Second remarks on a pilot project of renewing the Oblá 14 house in Brno, Nový Lískovec

Jan Hollan, Hvězdárna a planetárium M. Koperníka v Brně

May 7, 2003

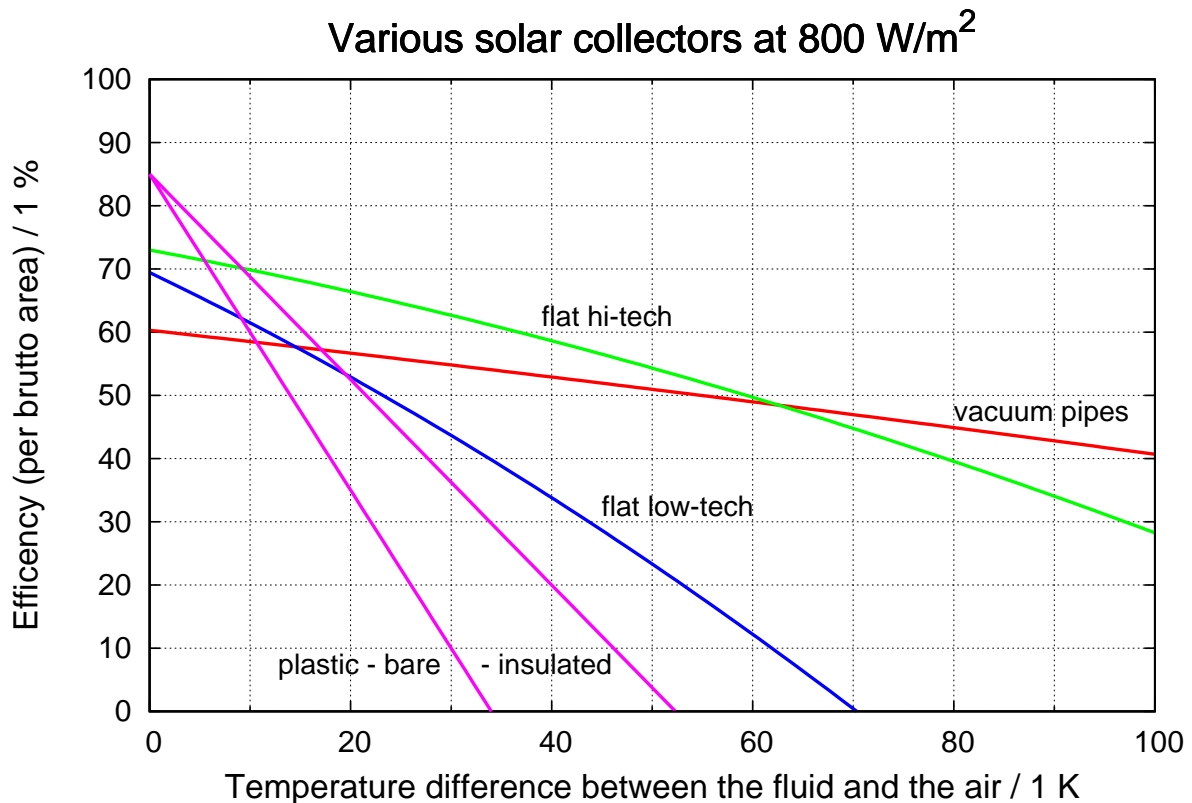
Just a comment for the tender: there is much larger difference between the low- and hi-tech collectors than I'd expect before I made the graph. At the left end, with zero temperature difference, it's due only to using either a standard or a solar glass (with low iron contents and high transmissivity). At the usual working temperature difference, 30 K, or in case of such a large system rather 40 K, the gain is really substantial – due to the much lower emissivity of the hi-tech absorbers. The best ones reach a value of just some 0.04, and these should be preferred of course over galvanic-treated ones with emissivities of more than 0.1.
